# **Report on Duke Energy Indiana's 2018 IRP**

**December 6, 2019**

**Anna Sommer, Energy Futures Group  
Chelsea Hotaling, Energy Futures Group  
Chris Neme, Energy Futures Group  
Elizabeth A. Stanton, PhD, Applied Economics Clinic**

**On Behalf of Citizens Action Coalition of Indiana, Energy Matters Community  
Coalition, Earthjustice, Carmel Green Initiative, Environmental Working Group,  
Indiana Distributed Energy Alliance, Sierra Club, and Valley Watch**

**Figure 1. Sources of Energy in Preliminary Duke Reference Case Run<sup>16</sup>**

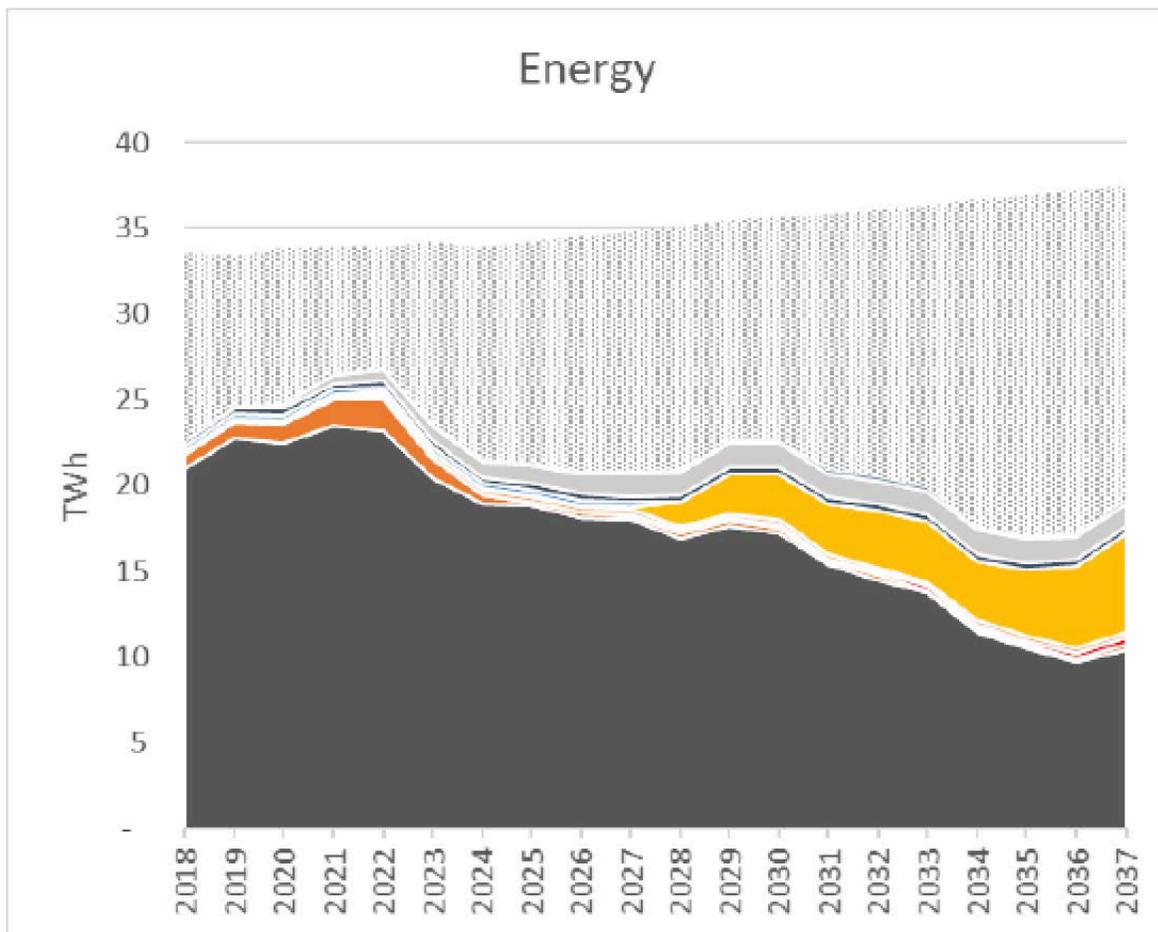
A seasonal RA construct clearly does not meet any of these three criteria. **We view this assumption as a fatal flaw in Duke’s modeling.** Throughout its runs presented during the stakeholder workshops, there was a pattern of retaining generators and buying enormous quantities of energy out of the MISO market. This is shown, for example, in Duke’s Reference Case with a Carbon Tax presented at its December 18, 2018 workshop and replicated here as Figure 1.

**Figure 4. Comparison of Duke’s Actual Retail Sales to Forecasted Sales (MWh)**

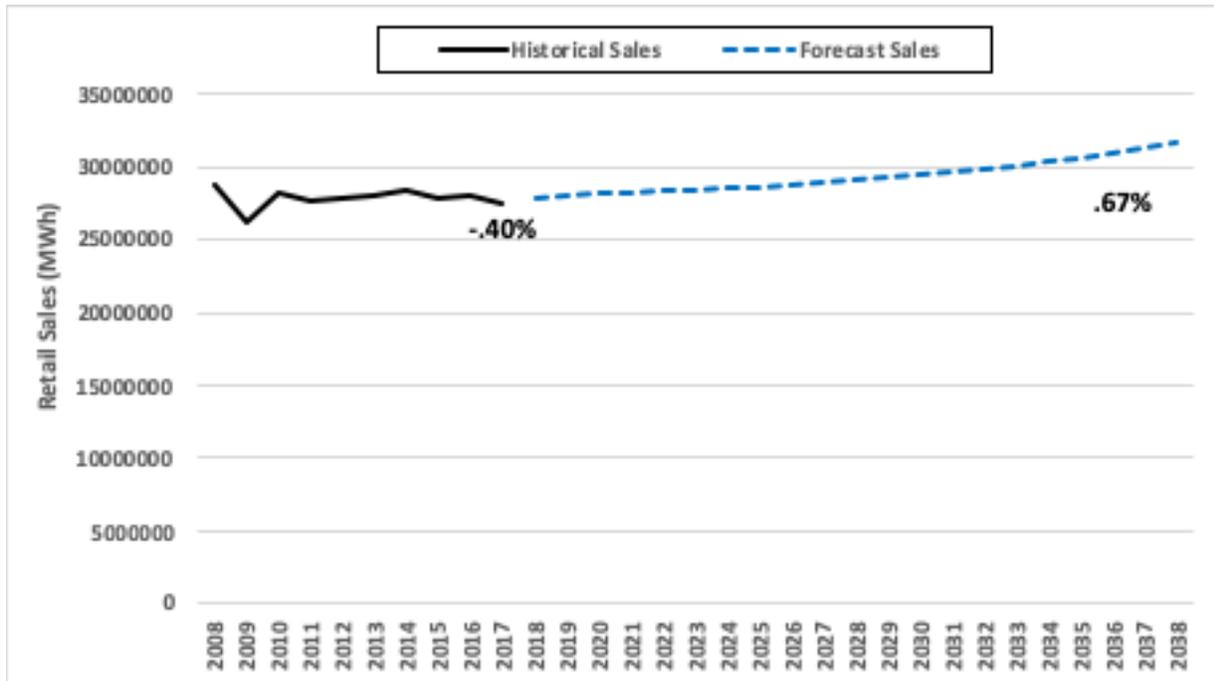
Duke predicts a higher growth rate in sales and peak demand than it has experienced over the last eleven years. Figure 4, below, shows how Duke’s forecast compares to the historical.

Figure 5. Comparison of Duke's Actual to Forecasted Retail Peak Demand (MW)<sup>43</sup>

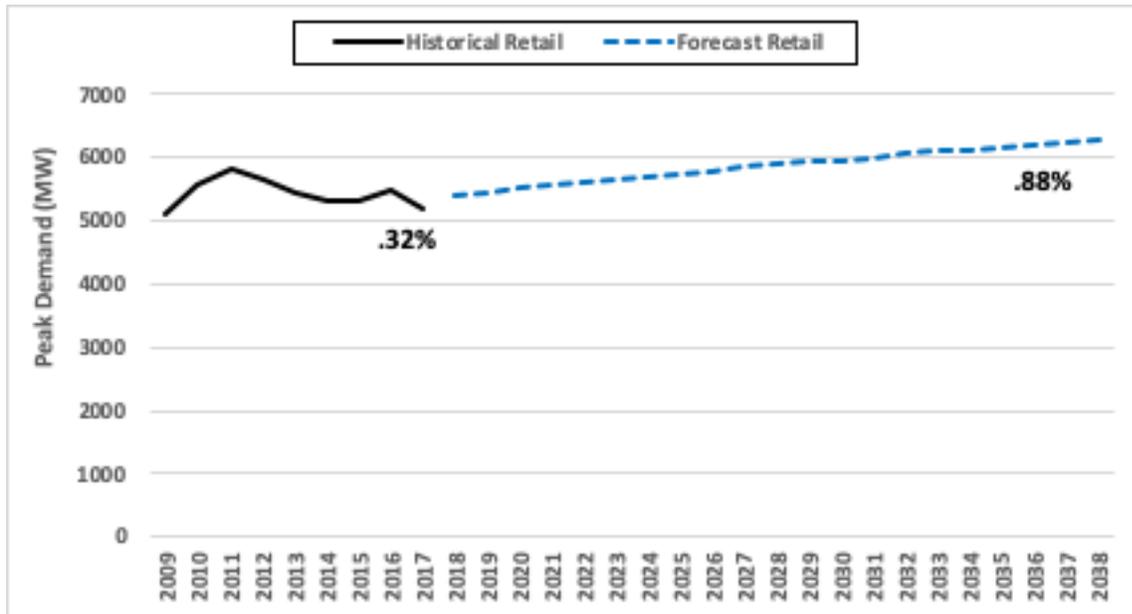
Duke is also forecasting an increase in its peak demand over the planning period. Figure 5, below, highlights the difference between the historical and forecasted peak demand and also includes the peak demand when considering the wholesale requirement customers. Duke will lose some wholesale requirements customers, so their contribution to peak demand falls slightly during the planning period. We recognize that the projection does not include new utility-sponsored DSM while the historical does. We would also note that had Duke complied with Rule 170 IAC 4-7-6 (a)(6) which requires, “A discussion of demand-side resources and their estimated impact on the utility’s historical and forecasted peak demand and energy. The information listed above in subdivision (a)(1) through subdivision (a)(4) and in subdivision (a)(6) shall be provided for each year of the future planning period”, then this comparison accounting for DSM would have been readily available.

Figure 6. Comparison of Actual and Forecasted Sales by Customer Class<sup>44</sup>

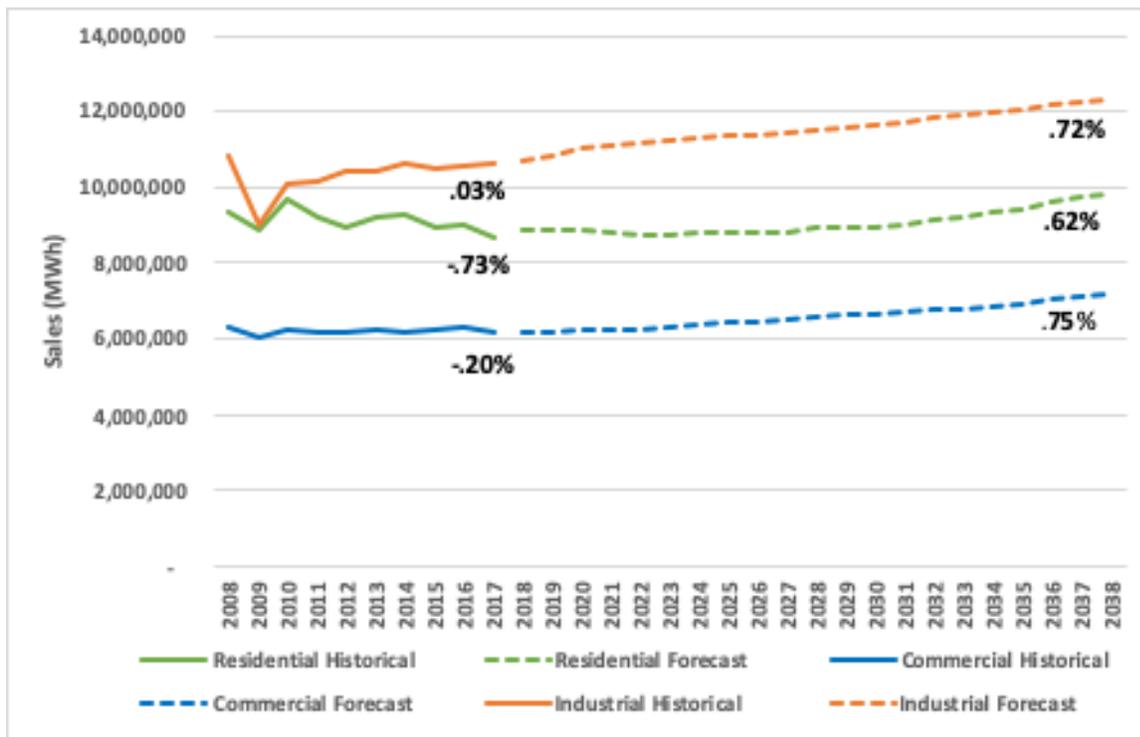
Duke projects increasing sales in all three sectors as depicted in Figure 6, below. Duke forecasts industrial sales at higher than historical levels since 2008, .72% compared to a historical rate of .03%. In the residential class the historical rate is -.20% while the forecasted average annual growth rate is .75%. And amongst commercial customers, the historical rate was -.73% while the forecasted average annual growth rate is .62%.

Figure 8. Comparison of Actual to Forecasted Average Use for Commercial Customers

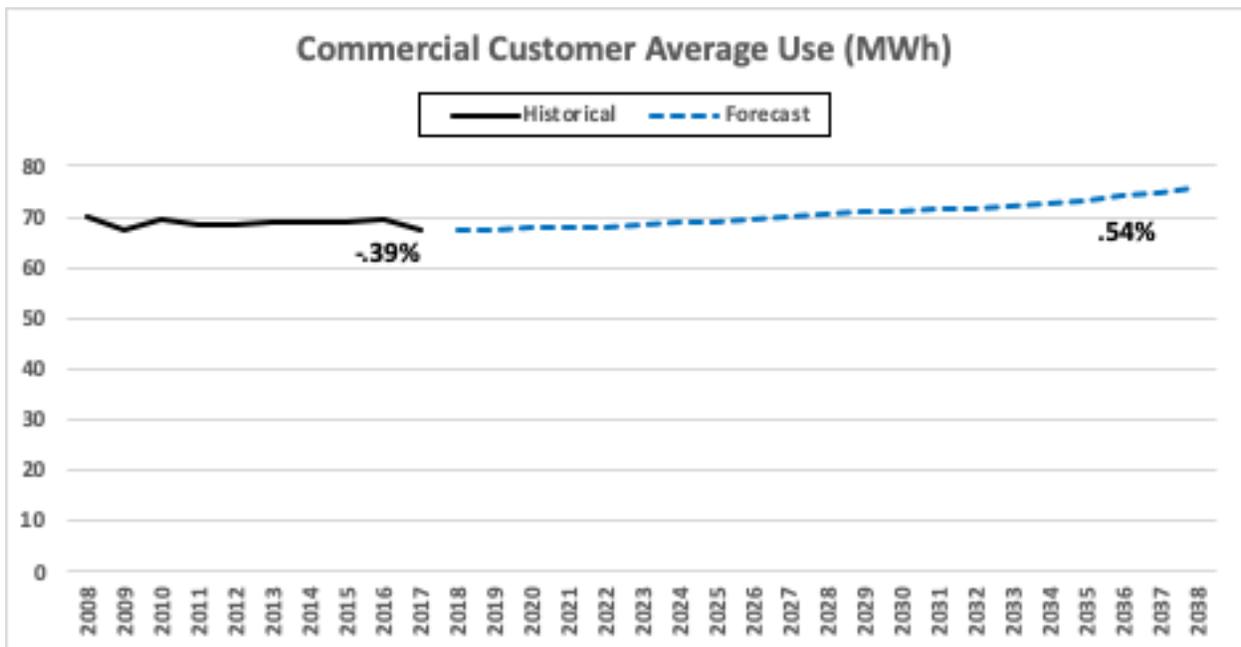
The driver of increased industrial sales is not an increasing numbers of customers but increased average utilization per customer (see Figure 7 below). Increased sales for the customer class is also driven by an increase in the average utilization per customer as depicted in Figure 8 below.

This increase has a significant impact on Duke’s load forecast and merits explanation. We think the difference is unlikely to be driven by EE impacts because so many of Duke’s industrial customers, 90% as a percentage of eligible load as of Dec. 31, 2018, have opted out of its EE programs. On the commercial side, we do not know what the explanation for the rate of growth might be.

Figure 9. Reproduction of Figure C.5 from Duke Energy Indiana 2018 IRP<sup>46</sup>

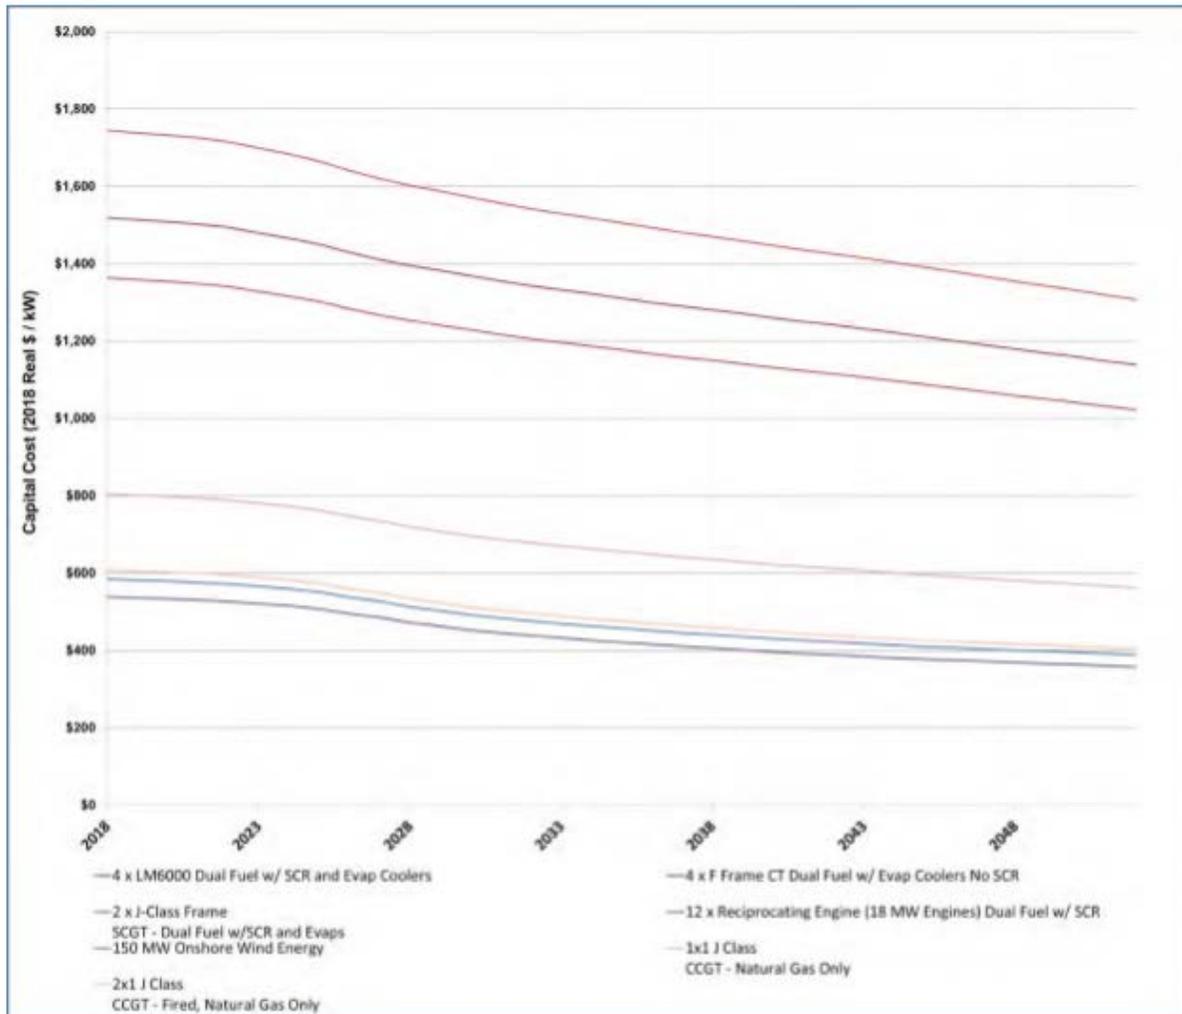
Figure 9 reproduces Figure C.5 from the IRP and shows the capital cost forecasts for select technologies not including solar or battery storage. Duke's projections for renewable and battery storage costs were provided in a data file to stakeholders, but are not contained in the IRP – a significant omission in Duke's IRP submission.

Duke’s description of how it developed the costs of all resources does not provide much meaningful information. It does not explain why Duke chose the U.S. Energy Information Administration (“EIA”) over several other capital cost sources that are more frequently used and considered more accurate sources for cost information particularly for renewables, i.e., NIPSCO’s Request for Proposal (“RFP”) responses and National Renewable Energy Laboratory’s (“NREL”) Annual Technology Baseline (“ATB”) Low Case. It does not explain why the “annual forecast factor” for metals would be necessary or preferable to, again, other cost sources that provide a long-term forecast of capital costs. Indeed, there is significant evidence that Duke’s projections for renewables, at least, are far too high.

Figure 10. Duke 2018 Energy Mix

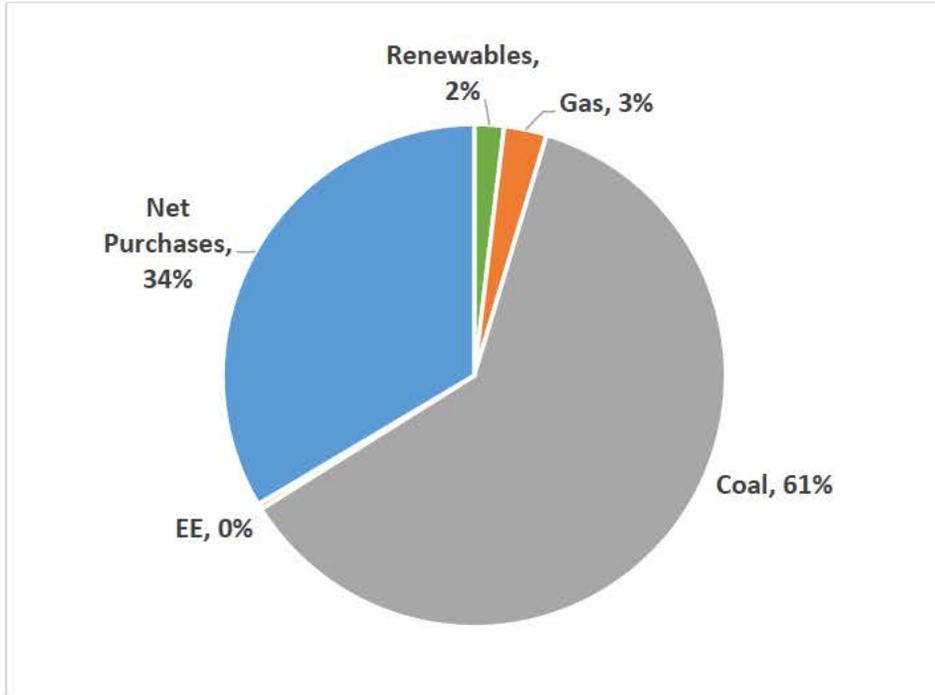
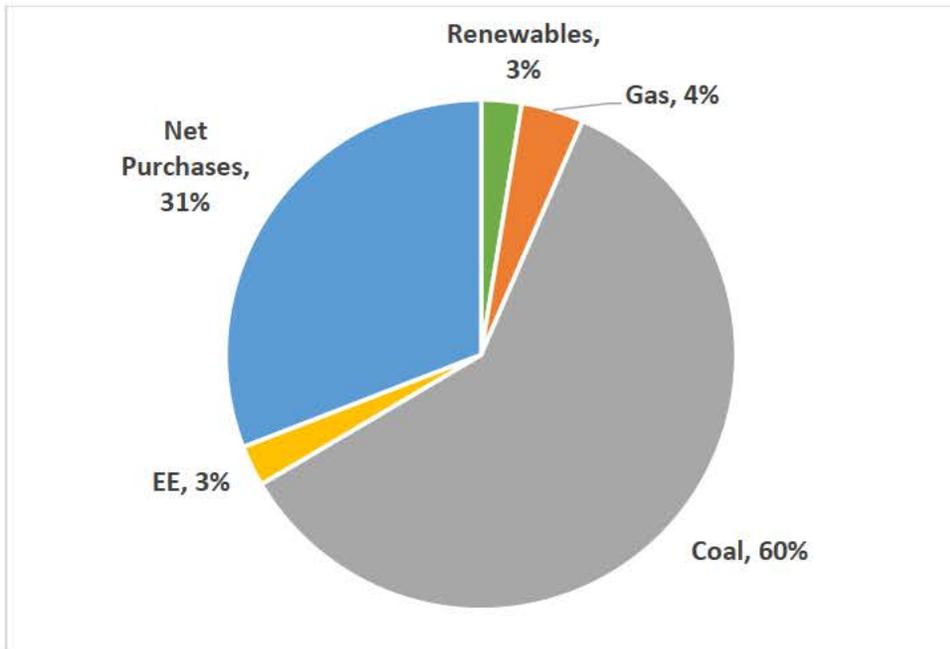
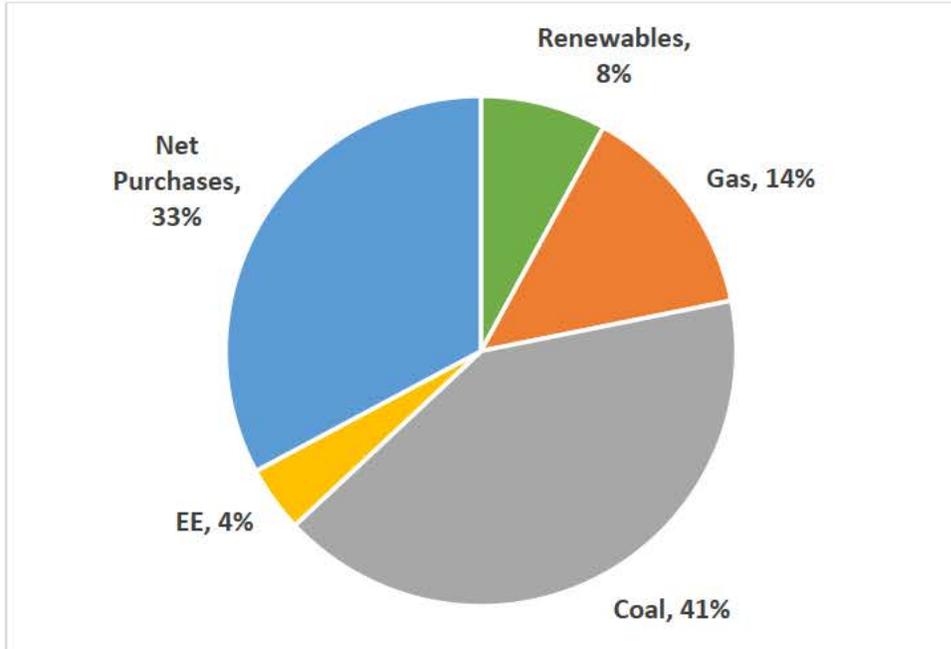
Duke’s 2018 Action Plan is a reflection of its modeling assumptions: very little changes until 2023 and even then the primary resource action, retirement of Gallagher Units 2 and 4, is merely the long delayed implementation of a decision made many years ago. Indeed, in its last IRP, Duke’s preferred plan would have retired the remaining Gallagher units in 2019. The change in retirement date to 2023 is neither discussed in nor supported by the 2018 IRP. This lack of “action” is inextricably linked to the many flawed modeling assumptions that underlie Duke’s 2018 IRP. Figure 10, Figure 11, and Figure 12 show that Duke plans to maintain its energy mix largely in the same manner that it currently exists now until 2028 when its preferred plan would add gas capacity. Renewables and energy efficiency grow only slightly, and net purchases remain largely the same.
